JOB NO. B94DK71A

PORT ALLEN SMALL BOAT HARBOR FLOATING DOCK IMPROVEMENTS

JOB NO. B94DK71A PORT ALLEN SMALL BOAT HARBOR PIER IMPROVEMENTS, KAUAI, HAWAII

AS-BUILT
08/31/2018

DRAWING TITLE: ABUTMENT A GENERAL ARRANGEMENT

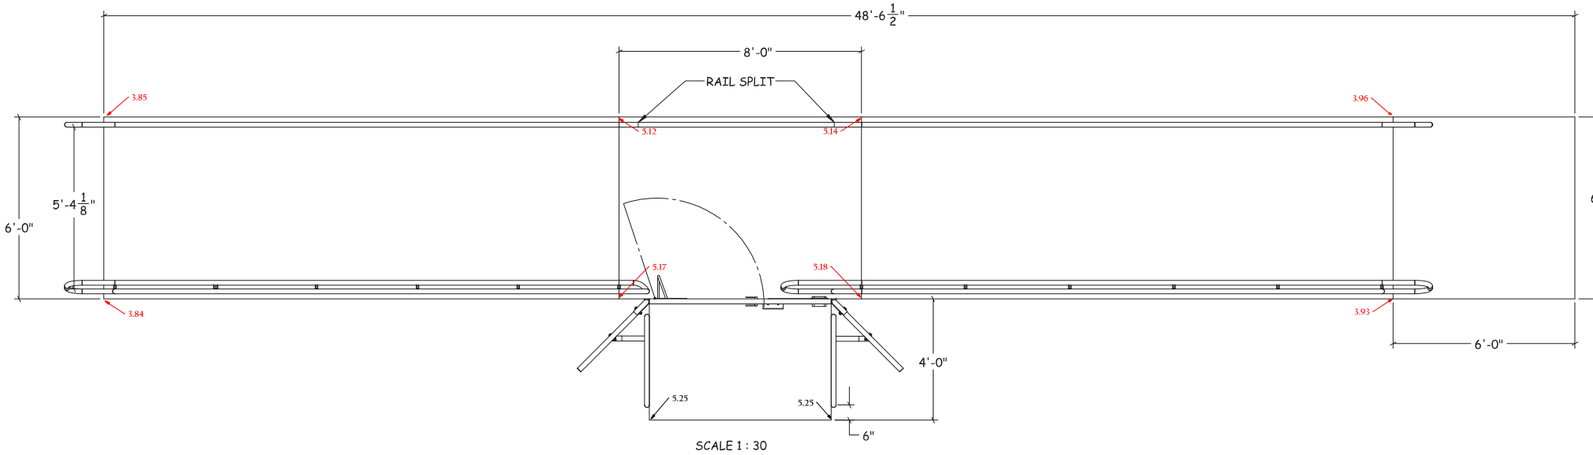
RFI 25: NOT ADA RAMP

Drawings given to HDCC only show return on handrail and not on guardrail, but providing both to be symmetrical

DRAWING TITLE: ABUTMENT B GENERAL ARRANGEMENT

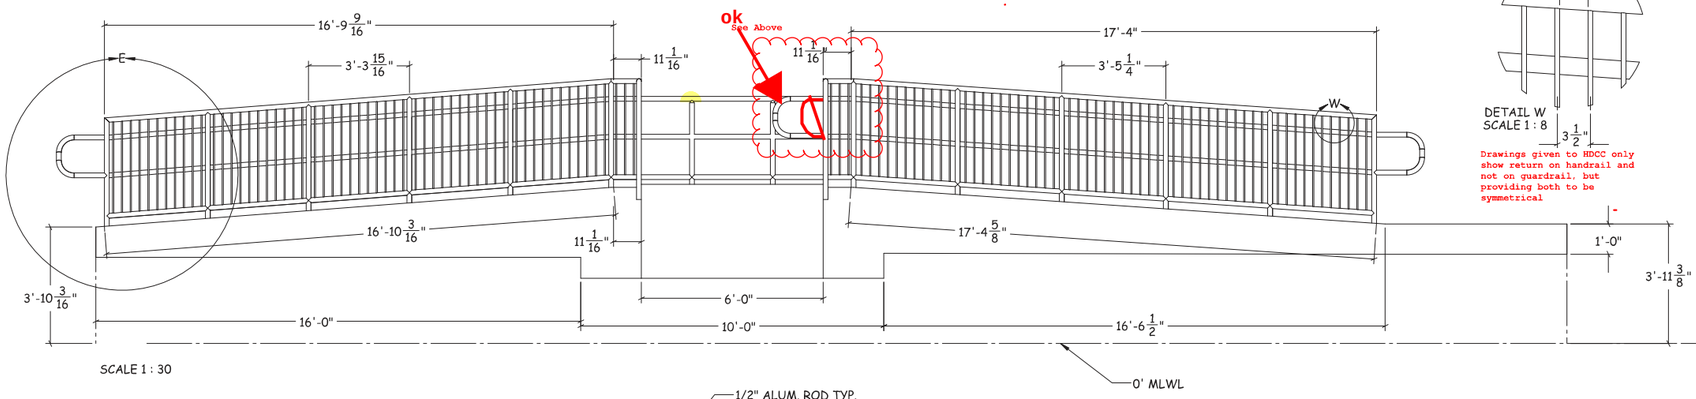
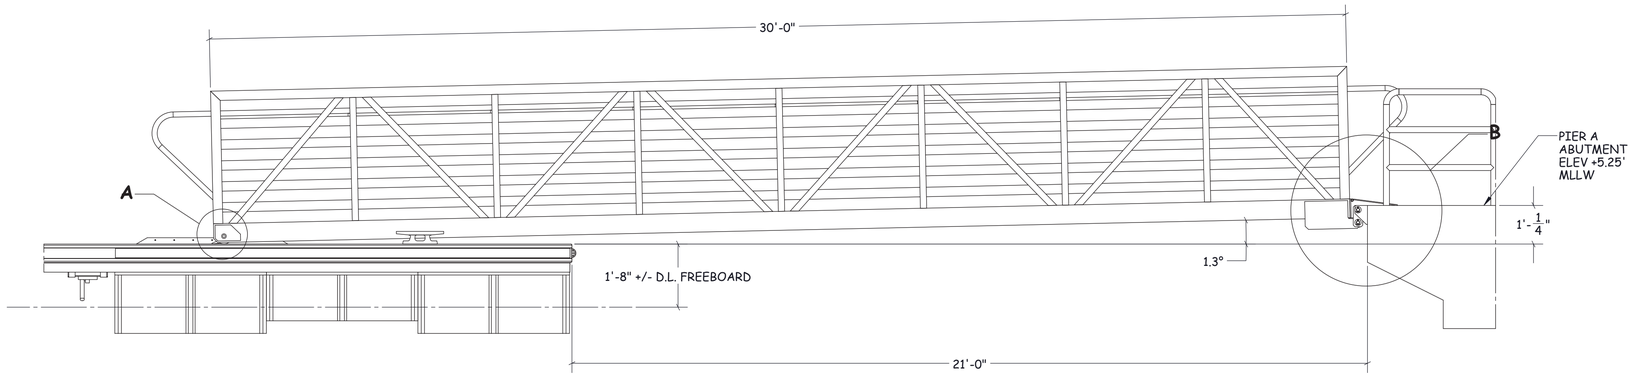
RFI 25: NOT ADA RAMP

RFI 25: ADA RAMP

Drawings given to HDCC only show return on handrail and not on guardrail, but providing both to be symmetrical

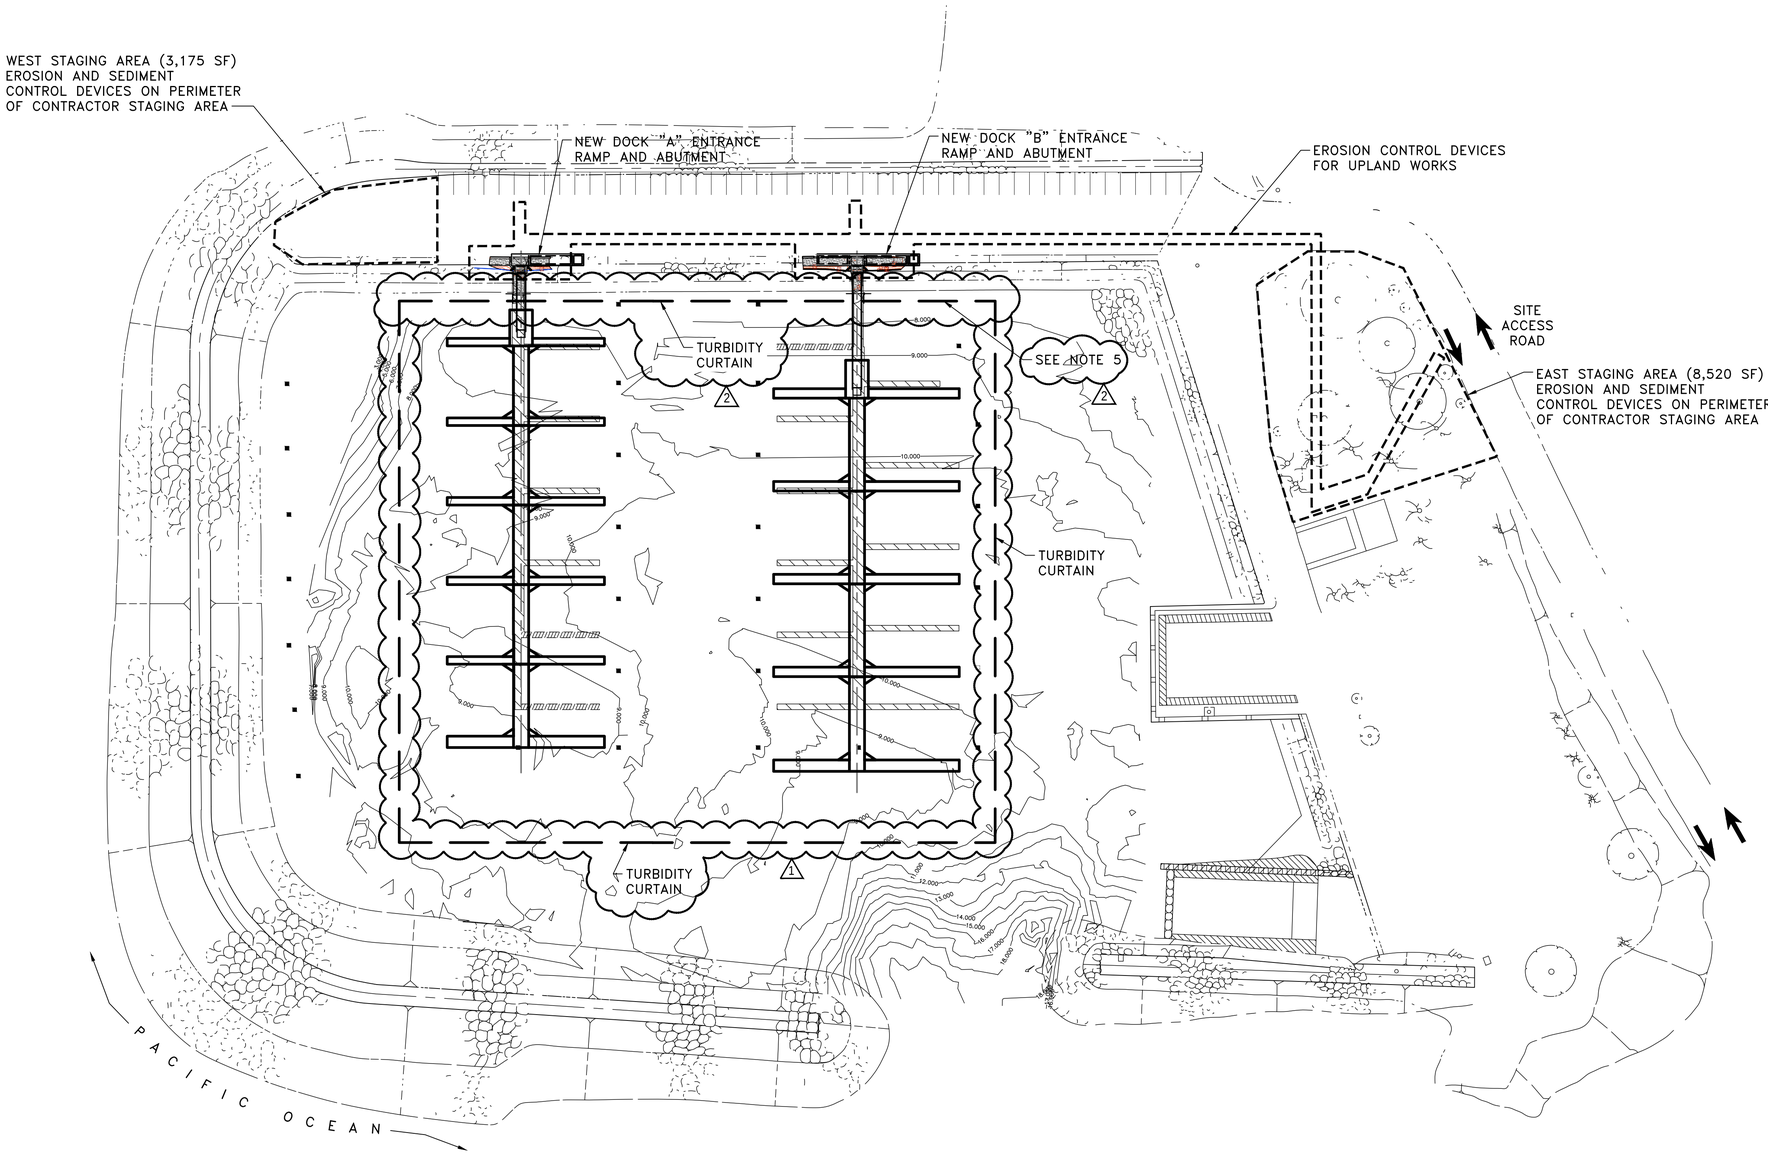
RFI 35: Benchmark transfer as PAH-1 will be demolished during construction of abutment B

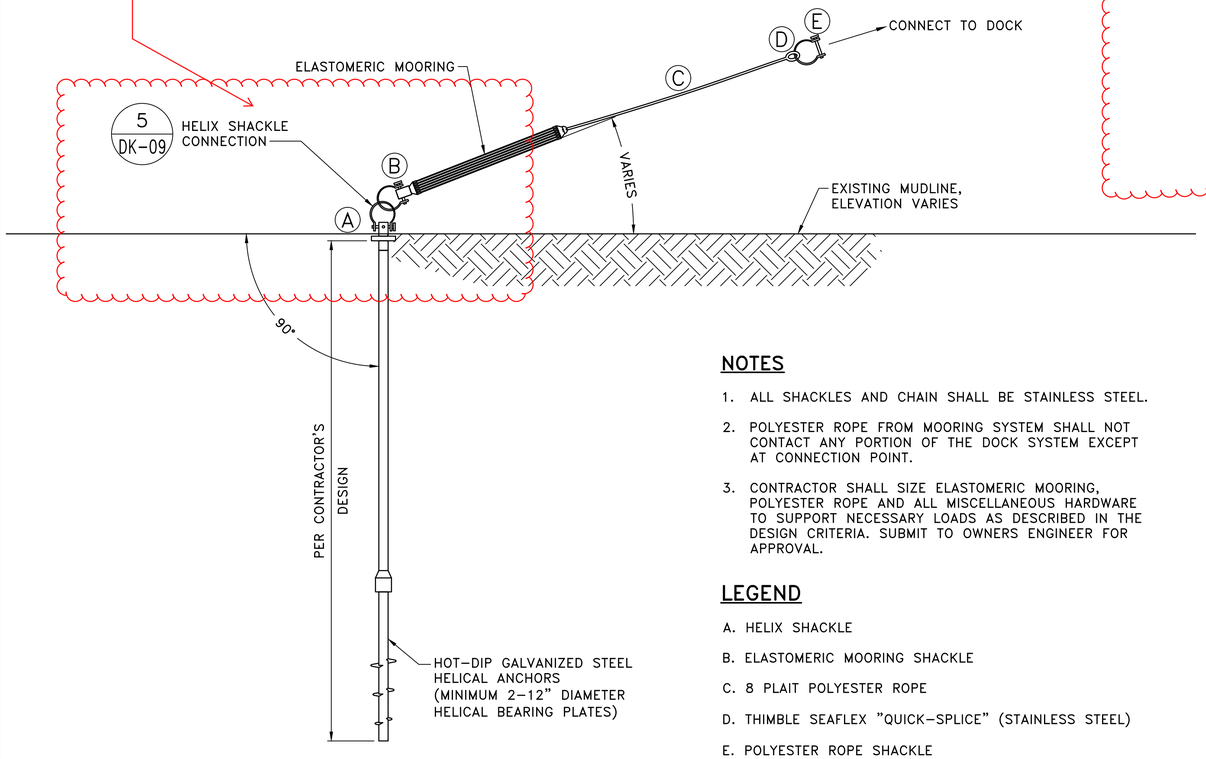
ADD 1: Contractor's design engineer shall evaluate dissimilar metals and select. Shackles are HDG, which shall be minimum.

Submittal 6BR1: Providing HDG anchor shackle as HDG end for Seaflex

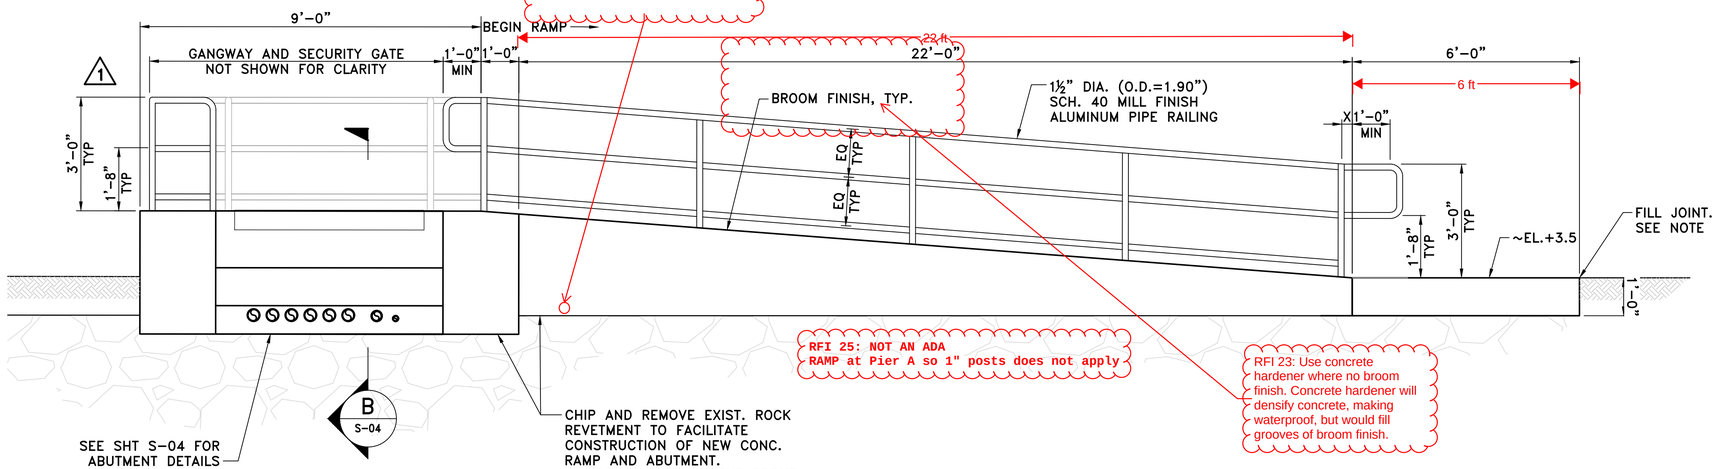
RFI 33: Provide 2" drainage weep hole as taking away low point for storm water run off

RFI 25: NOT ADA RAMP

RFI 25: NOT AN ADA RAMP at Pier A so 1" posts does not apply

1 S-16 SECTION
SCALE: 1/2" = 1'-0"

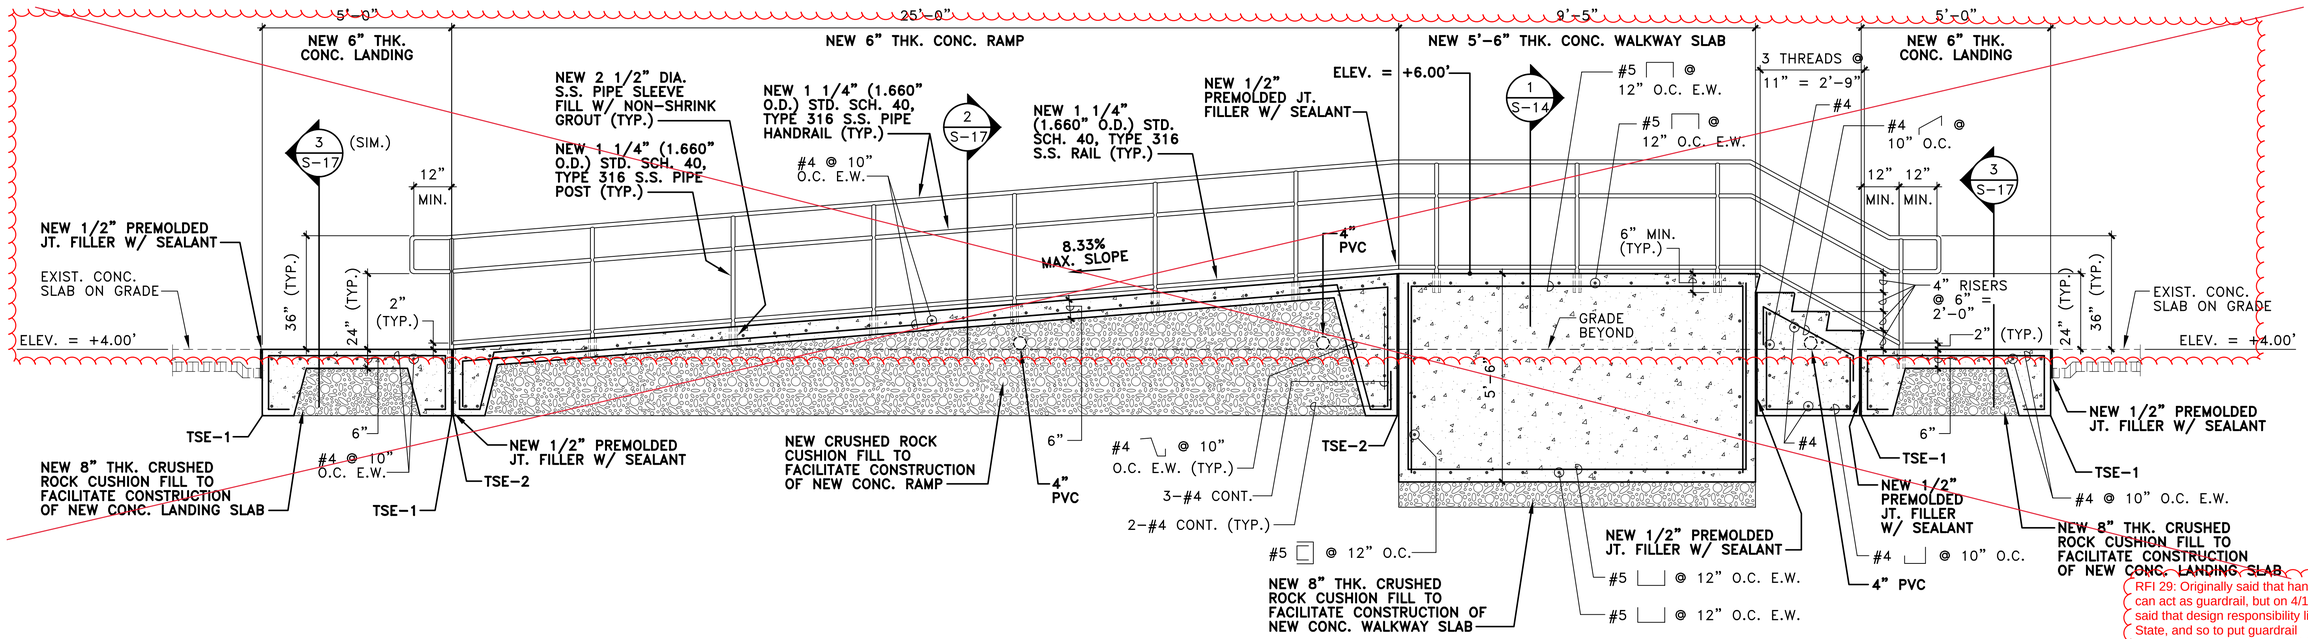
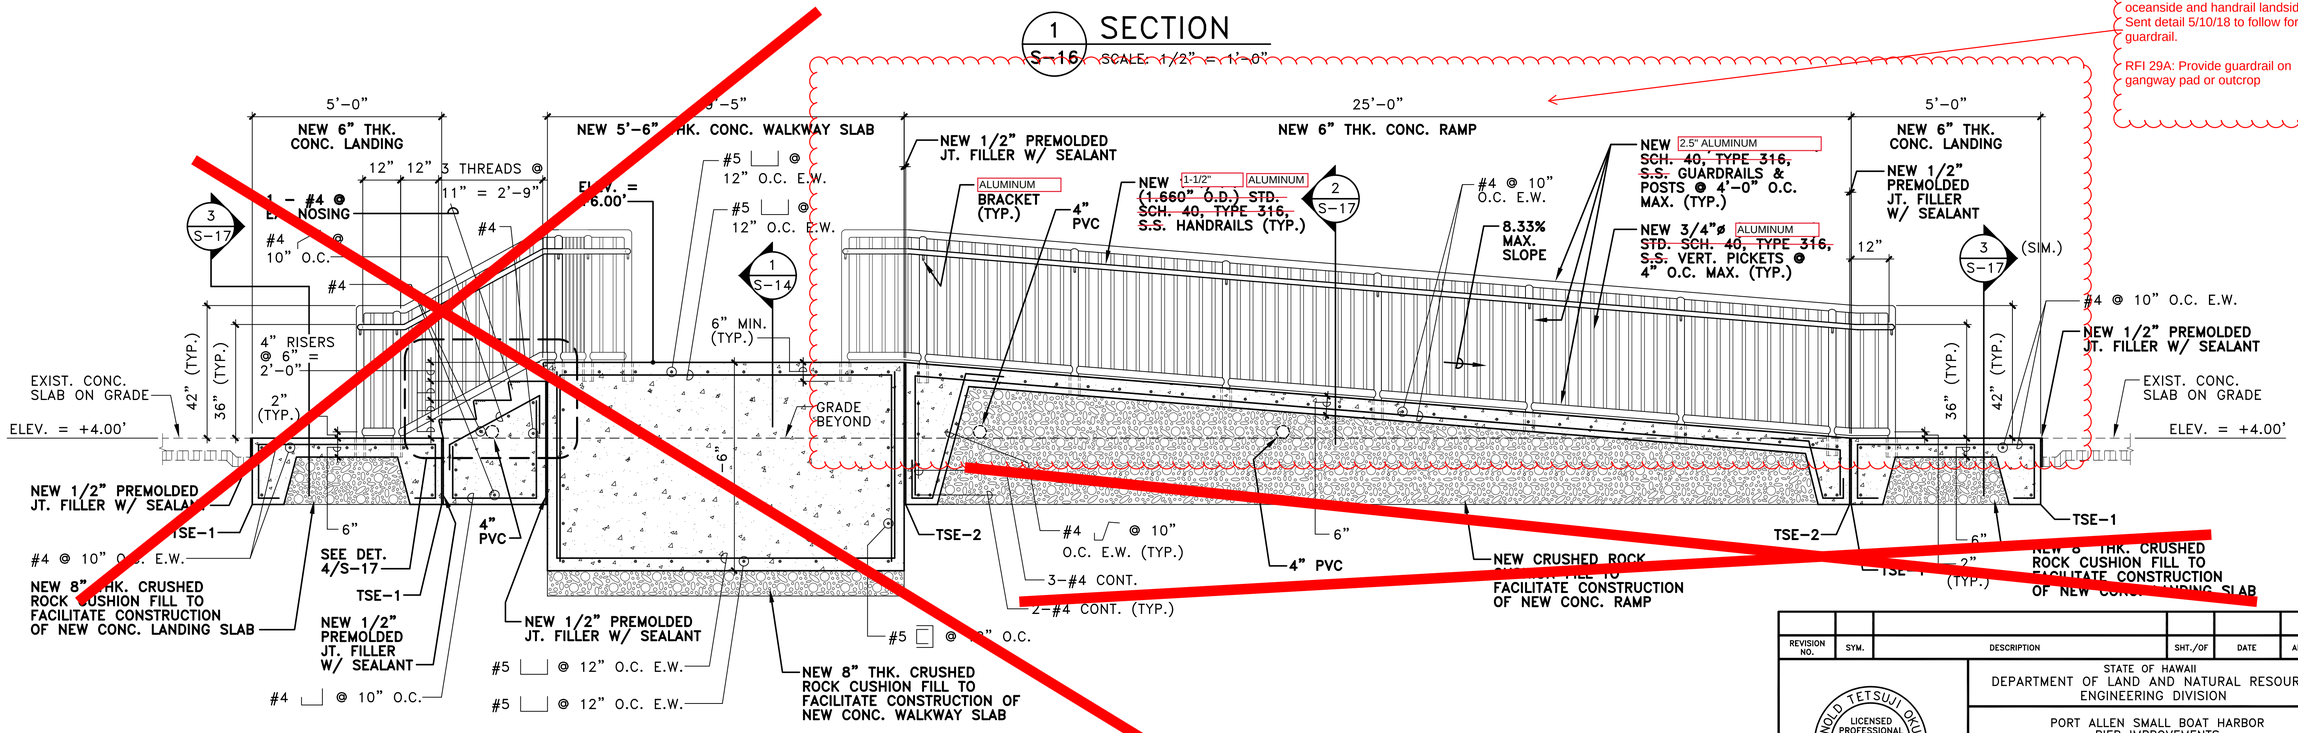
RFI 29: Originally said that handrail can act as guardrail, but on 4/12/18, said that design responsibility lies with State, and so to put guardrail oceanside and handrail landside. Sent detail 5/10/18 to follow for guardrail.

RFI 29A: Provide guardrail on gangway pad or outcrop

3 M-05 PARTIAL DOCK PIPING PLAN

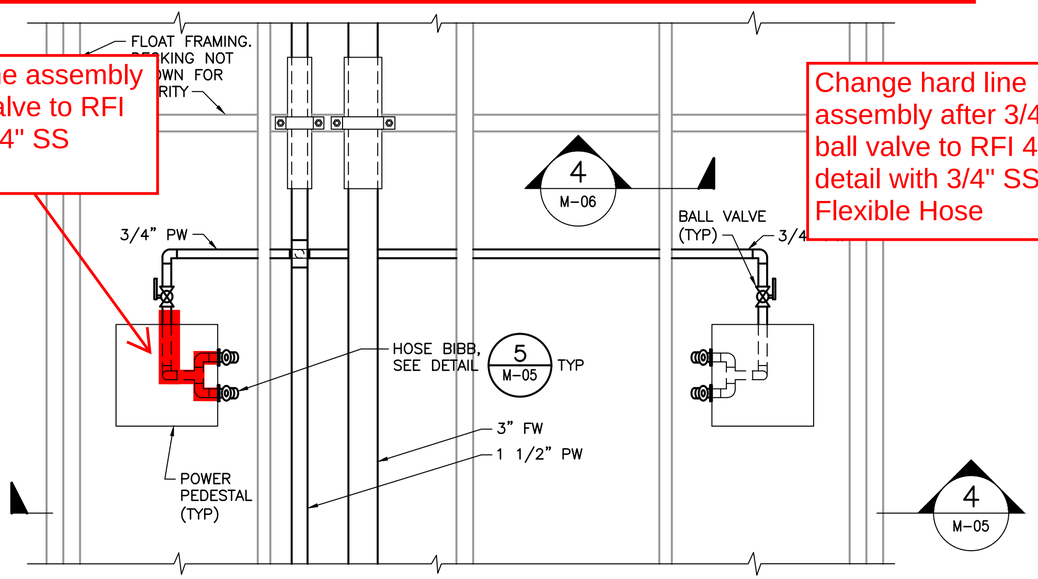
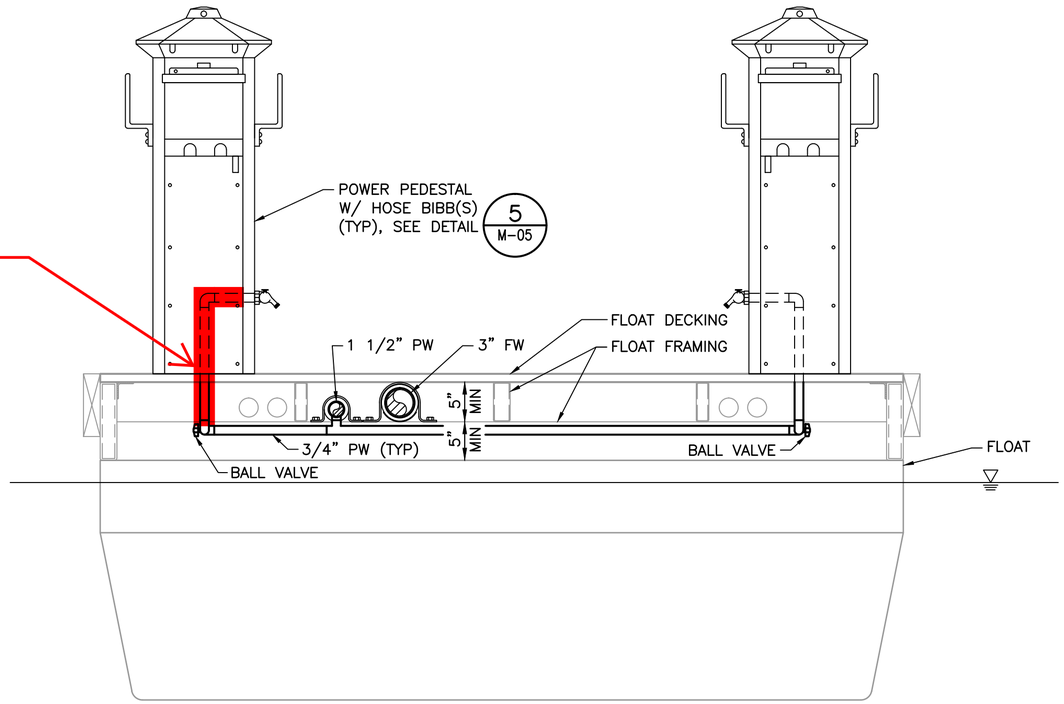
RFI 43: State accepted on 6/6/18

Change hard line assembly after 3/4" ball valve to RFI 43 detail with 3/4" SS Flexible Hose

Change hard line assembly after 3/4" ball valve to RFI 43 detail with 3/4" SS Flexible Hose
